**LUSB-A111-00 (USB 2.0)
DESIGN CHANGE FOR LOCKING LATCH
(WITH RIBS)**

**LUSB TYPE A RIGHT ANGLE RECEPTACLE,
LOCKING LATCH FEATURES**

DWG. NO. **P-2444CF** REV **A**

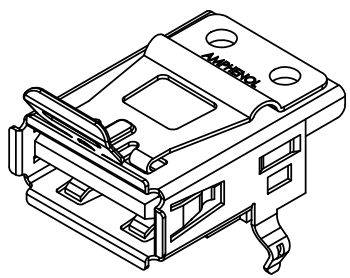
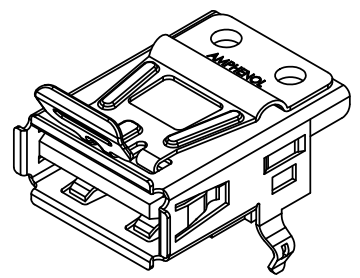
**LUSB-A111-00 (USB 2.0)
CURRENT DESIGN OF LOCKING LATCH
(WITHOUT RIBS)**

RIBS NOT PRESENT

ADDITION OF RIBS
ENHANCES RIGIDITY
OF LATCH AND MINIMIZES
PERMANENT DEFORMATION
IF LATCH IS OVER-STRESSED

THE LOCKING LATCH ON LUSB-A111-00 HAS BEEN MODIFIED TO INCLUDE RIBS IN THE POSITIONS SHOWN ABOVE.

THIS WILL BE A RUNNING DESIGN CHANGE. REFER TO THE PRODUCT CHANGE NOTICE FOR THE ESTIMATED DATE FOR IMPLEMENTATION.
